**DEFENSE NUCLEAR FACILITIES  
SAFETY BOARD**

The Defense Nuclear Facilities Safety Board (Board) completed a review of a revised preliminary documented safety analysis for the High-Level Waste Facility at the Waste Treatment and Immobilization Plant project located at the Hanford Site. The review was limited to the hydrogen control strategy, as well as fire protection and chemical safety programs.

### Review of the Preliminary Documented Safety Analysis for the High-Level Waste Facility

**Figure 2.** A plot of the LFL of hydrogen as a function of temperature (derived from [17]).

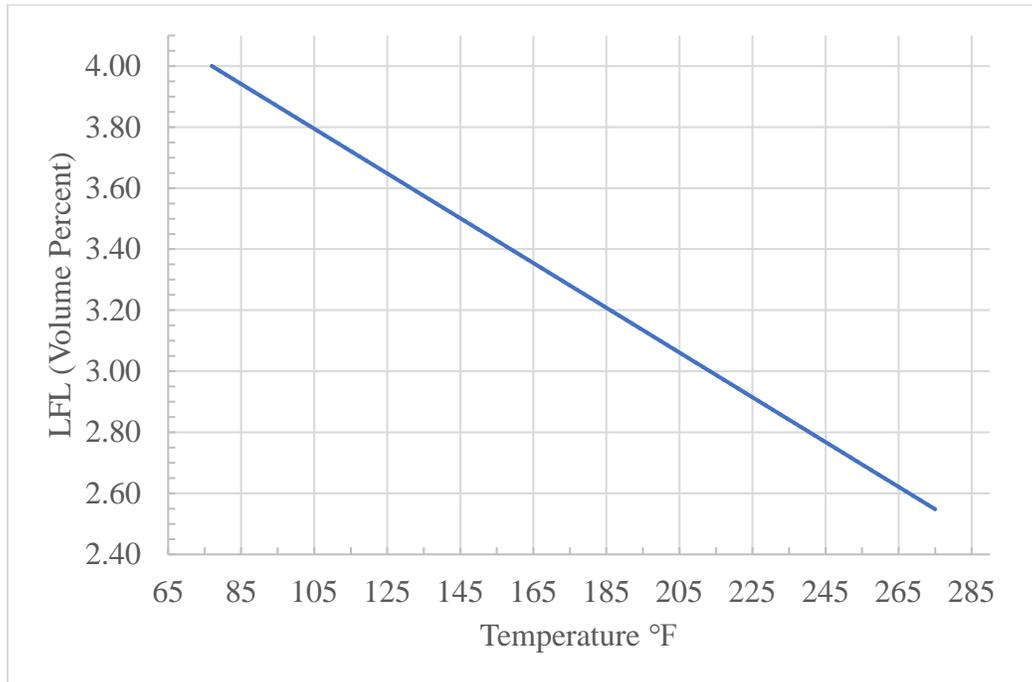
*Observation 4: Temperature Effects Are Not Fully Considered in the Volcanic Ashfall Safety Strategy*—As discussed, the control strategy for a volcanic ashfall event includes a passive safe shutdown of the facility that secures electrical power to all systems. With ventilation and other cooling systems shut down, the facility’s temperature will increase. This temperature increase was not considered in the safety analyses of hydrogen hazards during the ashfall event.

Project documents show that facility air temperatures could reach beyond 267 °F during the passive safe shutdown. There are three impacts to safety analyses for hydrogen hazards from an increased facility temperature:

1. Hydrogen generation rate increases with rising waste temperature. The hydrogen generation rate calculation is based on waste temperature in the HFP vessels. The waste temperature calculation assumes a maximum 113 °F ambient air temperature within the C5 confinement boundary that contains the HFP vessels [16]. A higher ambient air temperature will increase the waste temperature, which in turn, will increase the hydrogen generation rate.
2. Increased facility temperature impacts flow dynamics in the HFP vessel and connected piping post-explosion. The FATE™ calculation used to determine HOP HEPA filter survivability following an HFP vessel explosion assumes a maximum temperature within the C5 confinement boundary equal to 113 °F.
3. Hydrogen’s LFL decreases with rising temperature. Figure 2 illustrates this effect.

DOE Standard 3009-94 states: “The range of accident scenarios analyzed in a DSA [documented safety analysis] should be such that a complete set of bounding conditions to define the envelope of accident conditions to which the operation could be subjected are evaluated and documented.” Project personnel plan to update the safety analyses for a volcanic ashfall event to consider the increased facility temperatures during the passive safe shutdown. They expect revised analyses to show that the facility temperatures will be lower than originally calculated.
